CITY OF ST. HELENS PLANNING DEPARTMENT STAFF REPORT

Appeal AP.1.25 – AP.3.25 of the Planning Commission’s denial of Variances V.1.25 – V.3.25

ZONING: Moderate Residential, R7
LOCATION: 35732 Hankey Road; 4N1W-4AB-100
PROPOSAL: Variances (x3) for reduced side yard (setback), reduced lot size, and reduced lot width for a potential future land partition application

APPEAL AP.1.25 - AP.3.25 CITY STAFF CREATED MAP

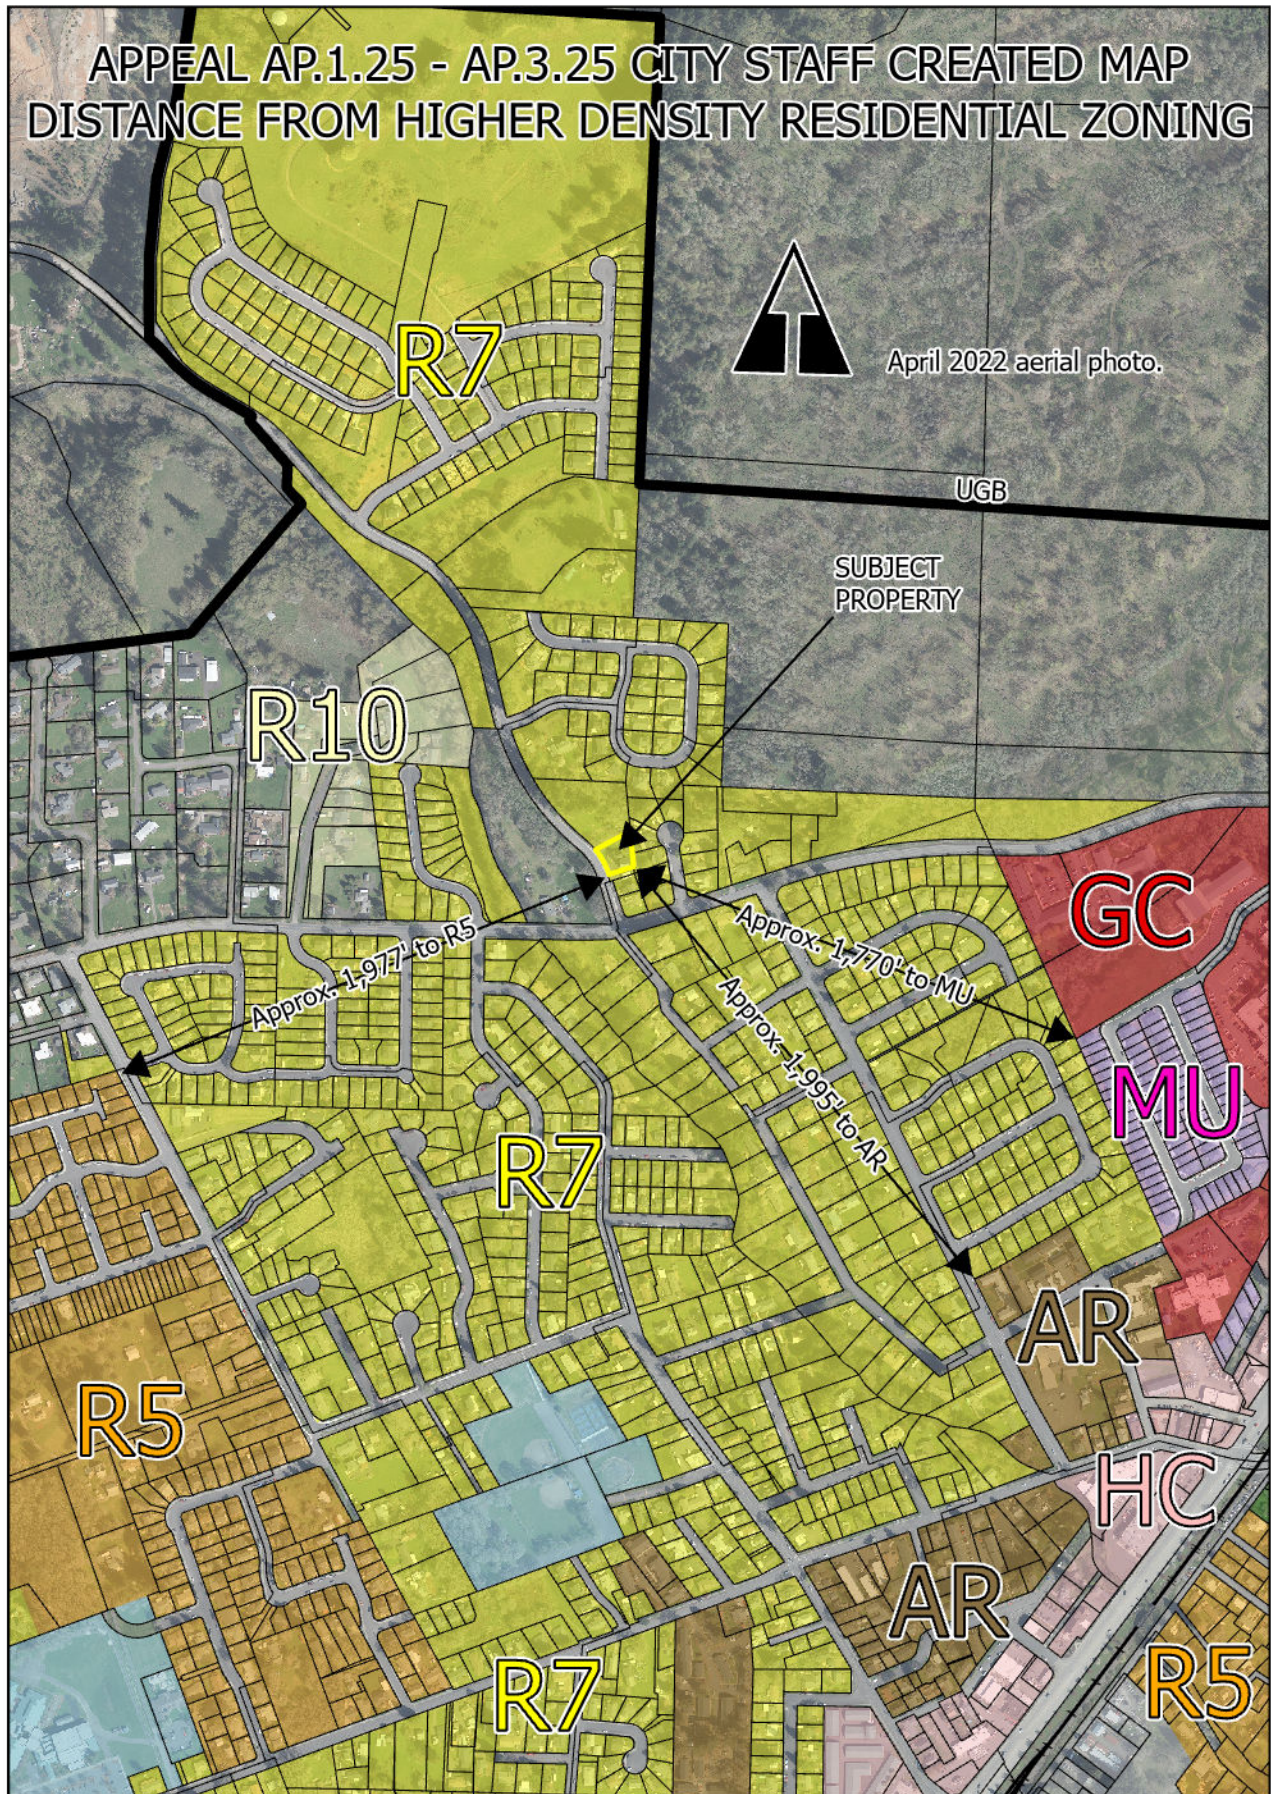
Long time existing access that provided access
to the 1985 dwelling. This access was separated
from the dwelling with the 2016 Lot Line
Adjustment (and why a new driveway between
the shop and Hankey Road was installed).

Proposed off-street parking
area for 1895 dwelling (accessed
via separate parcel).

Concept property line.

Attached garage/shop (2015).
Attachment unlawfully
removed 2021-2022.
